PROJECT NO. : 6492

ADDENDUM NO.: 1

ISSUED: 4/11/2024

Project: Sidewalk Replacement
VIT CUSD
1502 East US HWY 136
Table Grove, IL

DWG. NO. **C101**

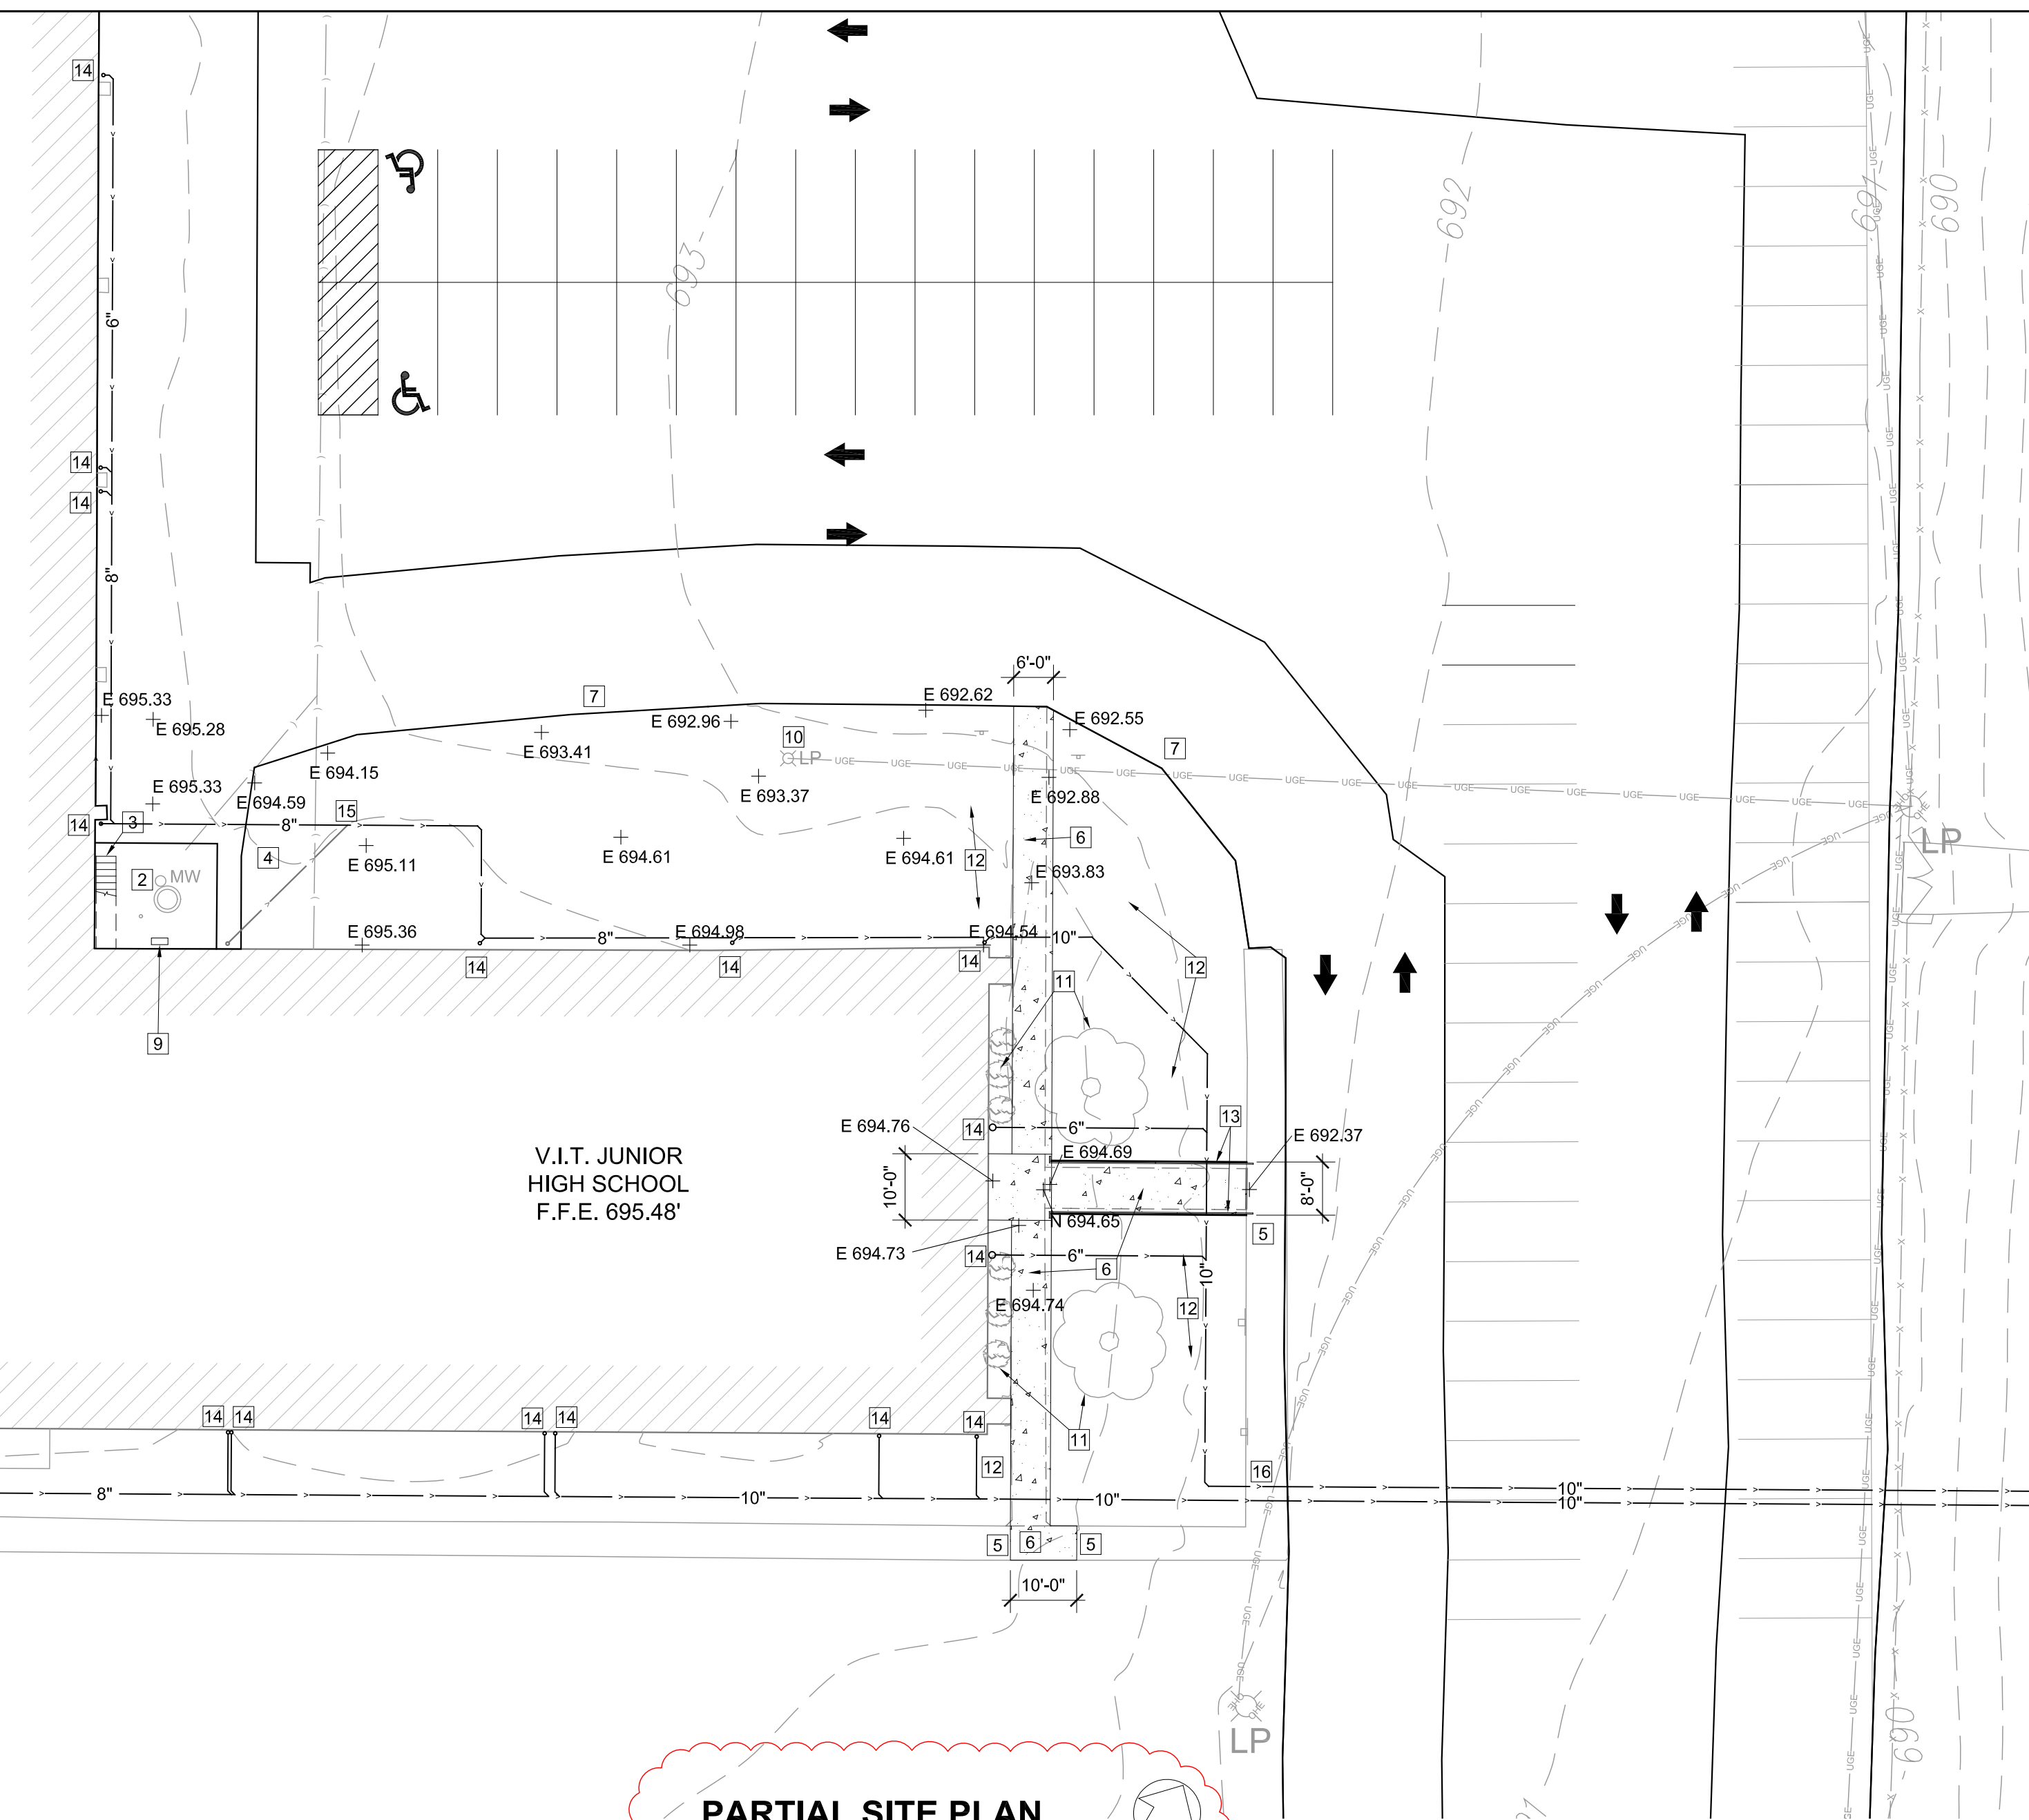
ITEM	DESCRIPTION
<u>Drawings</u>	
1.0 C101 Site Plan	Revise See attached revised plan adding storm water piping notes.

- GRADE AND RESEED IN THIS AREA AS REQUIRED
- NEW RAMP HANDRAIL, SEE DETAIL 3/C101 - RETURN 12" AT TOP OF RAMP, TYPICAL
- MODIFY EXISTING DOWNSPOUT AND INSTALL NEENAH OR EQUAL R-4927 SERIES DOWNSPOUT BOOT WITH BLACK PRIMER FINISH.

- MODIFY/EXTEND EXISTING DOWNSPOUT PIPING (SHOWN LIGHT) AND CONNECT TO NEW PIPING AS SHOWN.
- BORE (2) SETS OF 10" PIPING UNDER PAVEMENT AND TO DAYLIGHT AT HILLSIDE TO THE EAST AND TERMINATED WITH STAINLESS STEEL FLARED END SECTION.
